Access Compliance Report

Public Rights-of-Way

Intersection ID: 10040935	Main Street: WALLINGFORD_ST	Cross Street: N/A	Location: SW
ADA ID: E8668B85398D	Ramp Type: Perp	Initial Pass/Fail: Fail	Overall Compliance: No
			Severity Score: 26.25

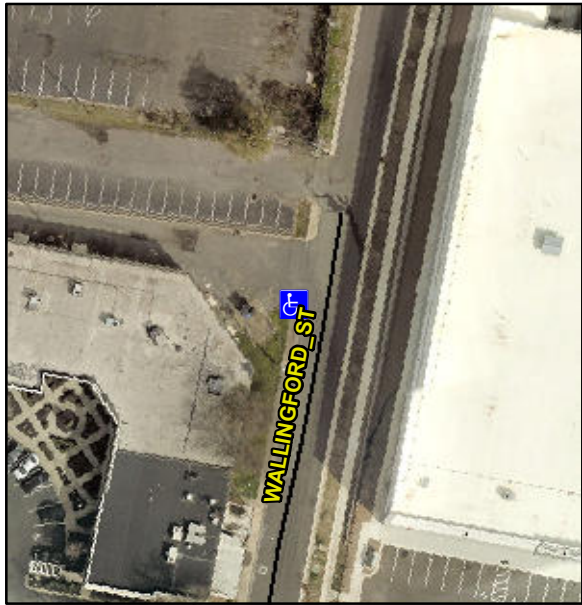
Codes/Mitigation Info/Possible Solution			Field Measurements/Component Compliance					
	Possible Solutions:		Compliance	Description	Data	Compliance	Description	Data
	Remove & Replace Entire Ramp.		N/A	Ramp Length (in)	44.0	No	Ramp Slope (%)	13.8
			Yes	Ramp Width (in)	50.0	No	Ramp XSlope (%)	3.3
			N/A	Flare Type LT	N/A	N/A	Flare Type RT	N/A
			N/A	Flare Slope LT (%)	N/A	N/A	Flare Slope RT (%)	N/A
			N/A	Flare Traversable LT?	N/A	N/A	Flare Traversable RT?	N/A
			N/A	Landing Length (in)	N/A	N/A	DWS Provided?	N/A
			N/A	Landing Width (in)	N/A	N/A	DWS Contrast?	N/A
			N/A	Landing Slope (%)	N/A	N/A	DWS Length (in)	N/A
			N/A	Landing X Slope (%)	N/A	N/A	DWS Full Width?	N/A
Surveyor Notes:		N/A	N/A	Landing Curb? (Y/N)	N/A	N/A	DWS Offset (in)	N/A
PROW/ADA:		Not Found, R304.2.2, R304.5.3	N/A	Shared Landing?	N/A			
			N/A	Gutter Ponding?	N/A	N/A	Gutter Slope (%)	N/A
			N/A	Gutter Lip Ht (in)	N/A	N/A	Gutter X Slope (%)	N/A

N/A	Painted X Walk1?	No	N/A	Painted X Walk2?	N/A
				X Walk 1 Direction	To N		X Walk 2 Direction	N/A
			N/A	X Walk 1 Width (in)	N/A	N/A	X Walk 2 Width (in)	N/A
				X Walk 1 Slope (%)	3.7		X Walk 2 Slope (%)	N/A
				X Walk 1 X Slope (%)	1.6		X Walk 2 X Slope (%)	N/A
			N/A	Ramp inside XWalk1?	N/A	N/A	Ramp inside XWalk2?	N/A
				Road Slope (%)	N/A	N/A	Clear Space?	N/A
				Road X Slope (%)	N/A	N/A	Clear Space to XWalk (in)	N/A
			N/A	Any Obstructions?	N/A	N/A	Storm Grate/Utility Hazard?	N/A
				Obstruction Type			Storm Grate/Utility Type	
					N/A			N/A
						Yes	Surface Condition? (G/P)	Good
Street 1 Name		ENTRANCE						
Stop Condition-Street 2		None						
Street 2 Name		N/A						
Stop Condition-Street 1		N/A						
Total Cost:		\$ 1850.00
